AIWA CO., LTD
UTSUNOMIYA FACTORY

SERVICE TECHNICAL INFORMATION

MODEL : NSX-A303 and A304

SUBJECT : Addition or replacement of relay circuit

1. Identification method

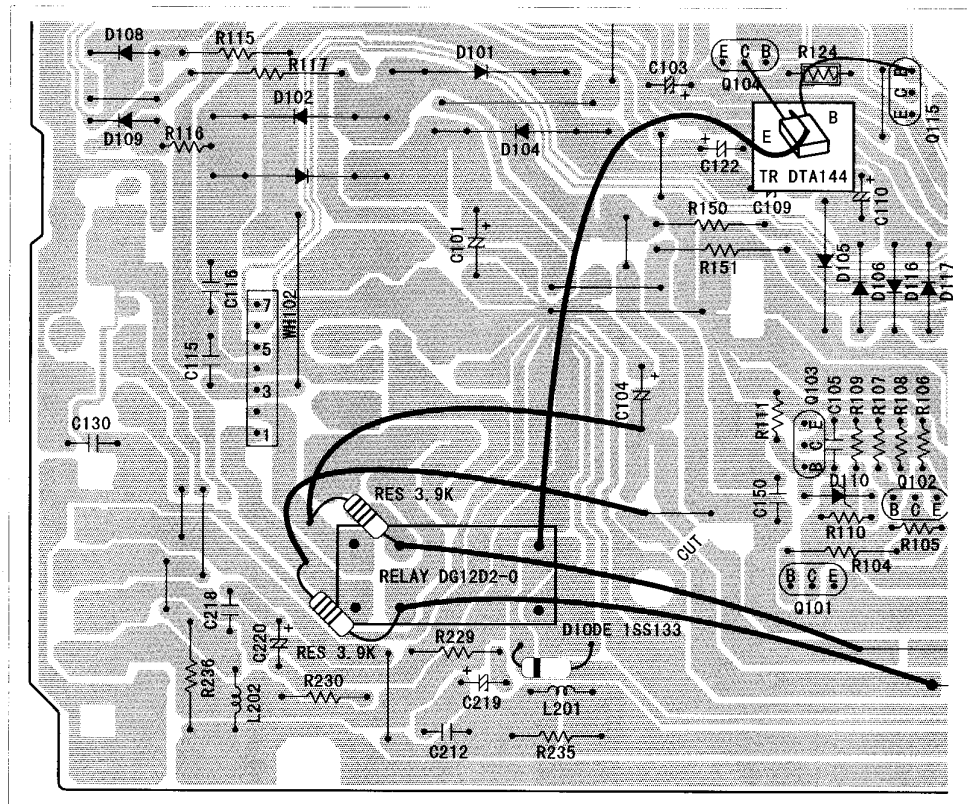
Relay circuit has been added to the units with "A" mark (white "A" letter on red) labels put on rear panel.

2. Pattern diagram

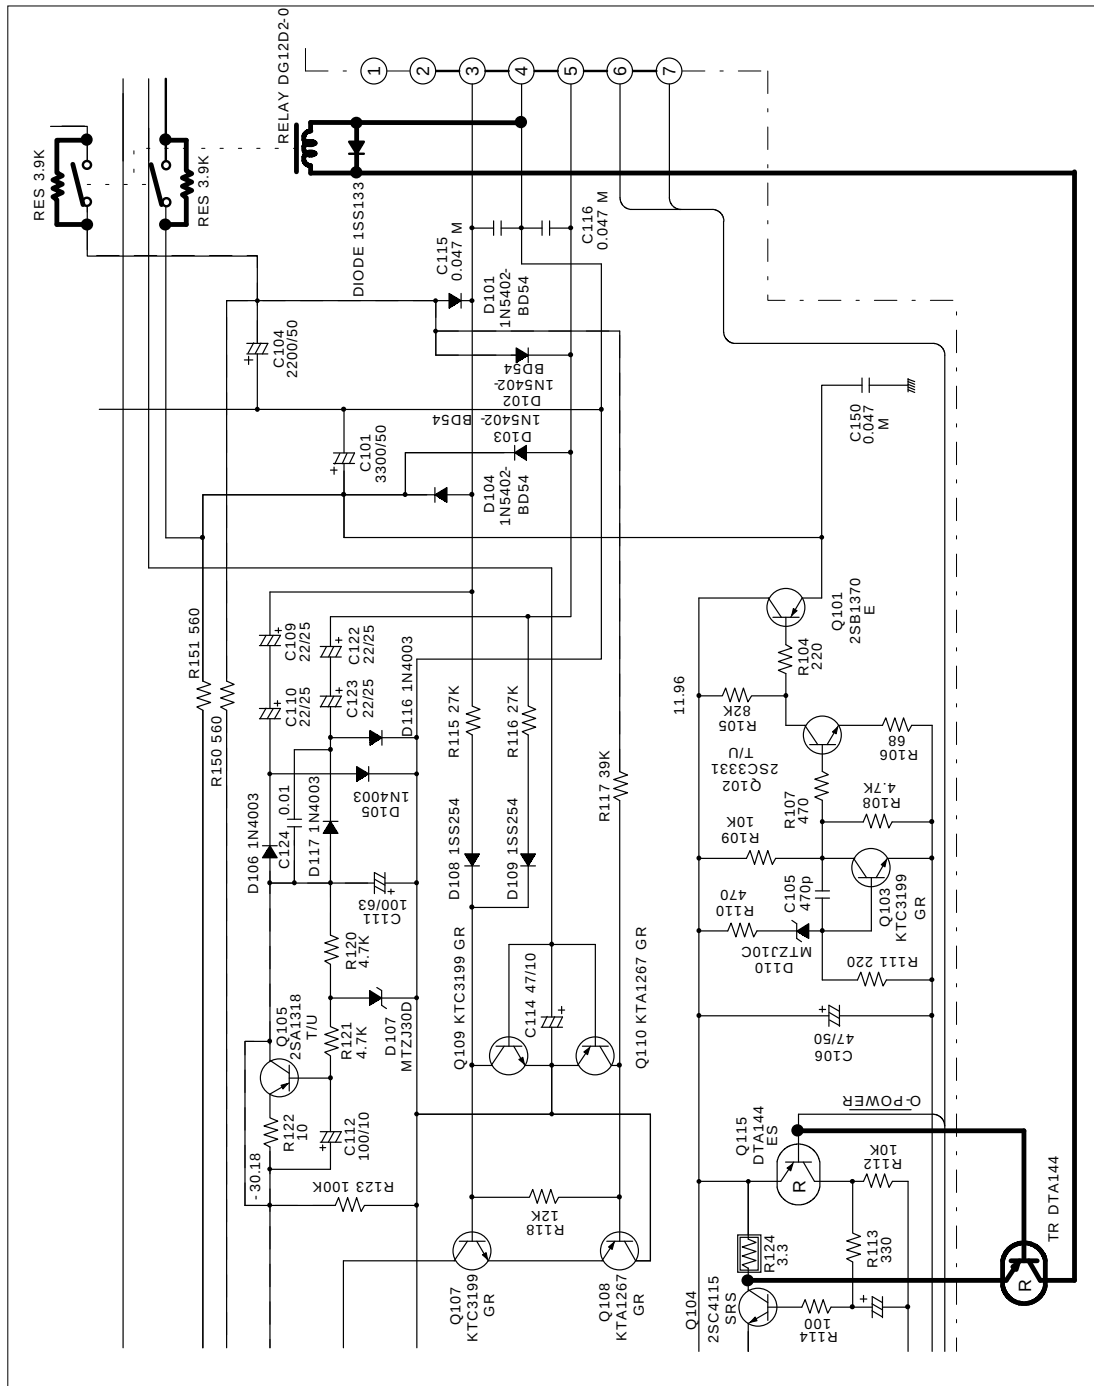
Relay circuit has been added to some of the products of the above models.

Before repairing, refer to the following identification method and circuit diagram, pattern diagram, and replacement parts list for details.
